**CIVIL AVIATION
AUTHORITY**

AIRWORTHINESS DIRECTIVES

SUBJECT INDEX

FUEL PRESSURE LINE MODIFICATION — DRAWING N° FM 07 —

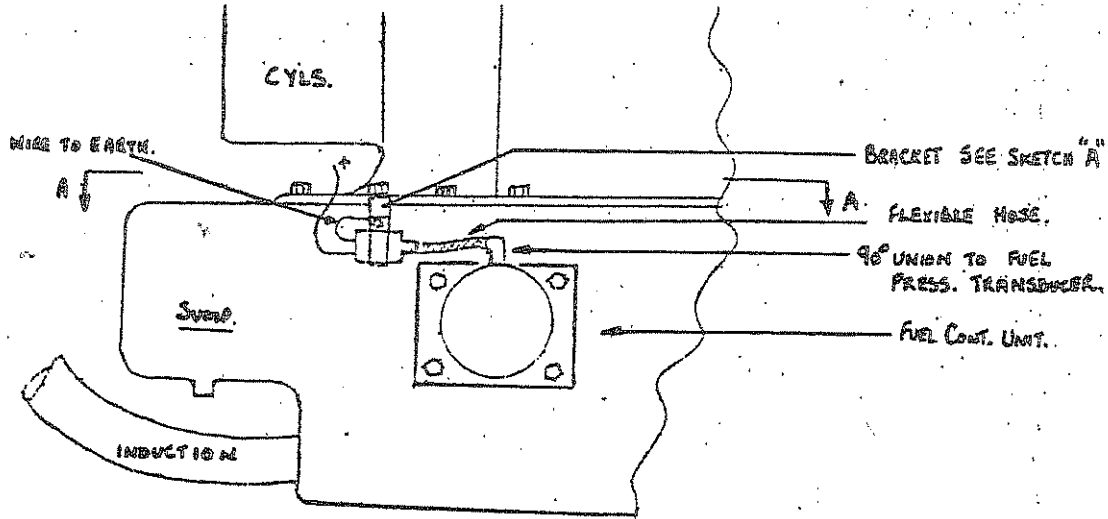
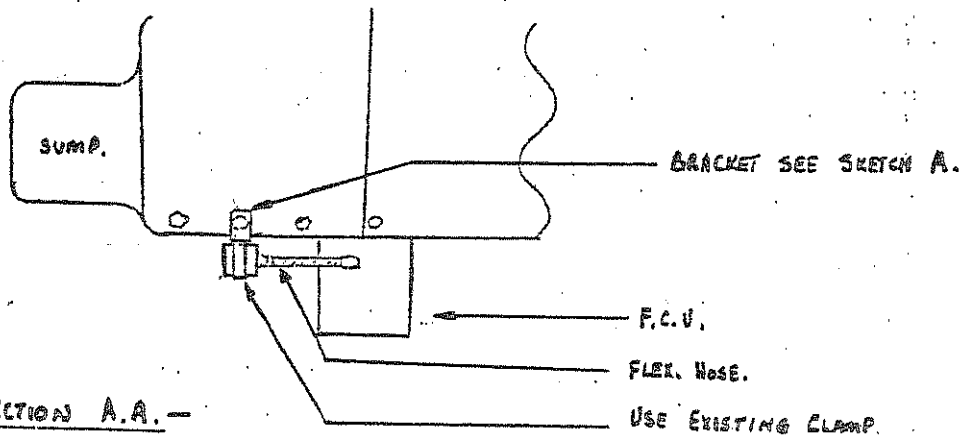
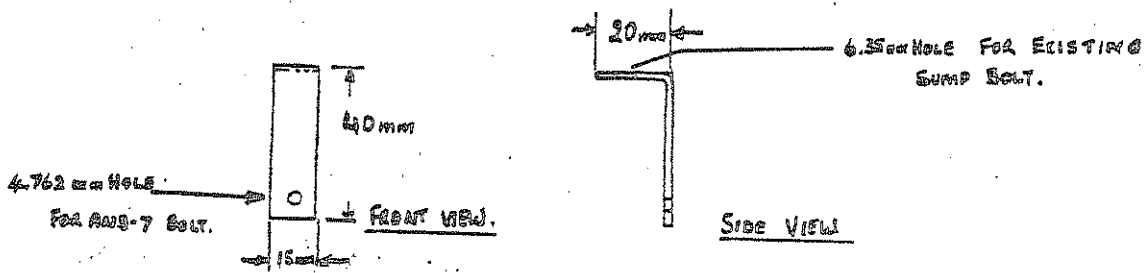
- (ii) Remove fuel pressure transducer from existing location (clamped to no. 3 cylinder induction pipe) and retain clamp and attaching hardware.
 - (iii) Manufacture bracket from 4130 steel to dimensions shown on sketch A, minimum thickness of 0, 060 and fit bracket to new position below no 1 cylinder utilizing existing sump attach bolt as indicated in sketch.

- (iv) Attach fuel pressure transducer to steel bracket with existing fuel pressure transducer clamp using AN 3-7A bolt, AN 960-10 washer and AN 363-1032 nut.

- (v) Manufacture new flexible hose, total length 11 cm, measured from outside ends of hose fitting nuts.
 - (vi) Original hose may be utilized and shortened, provided the hose is serviceable, by removing hose end fitting, which attaches to fuel pressure transducer, shortening hose to correct length and re-fitting hose end fitting.

Wiring Diagram Example:

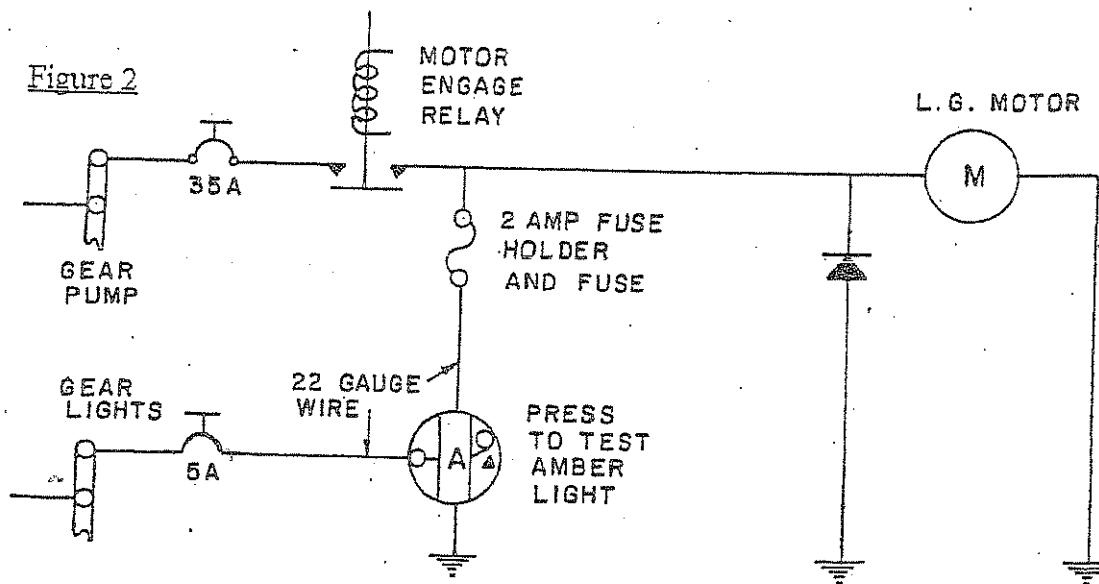
1. Install an amber warning light on the instrument panel in the cockpit where it is easily visible to the pilot.
2. Wire the warning light mentioned in 1 above into the aircraft wiring between the relay and the landing gear drive motor as indicated in Figure 2 below and install a 2 amp fuse holder and a fuse close to the pick-off point to protect the wiring.
3. Placard the newly fitted amber light with placard wording as indicated by Figure 1.
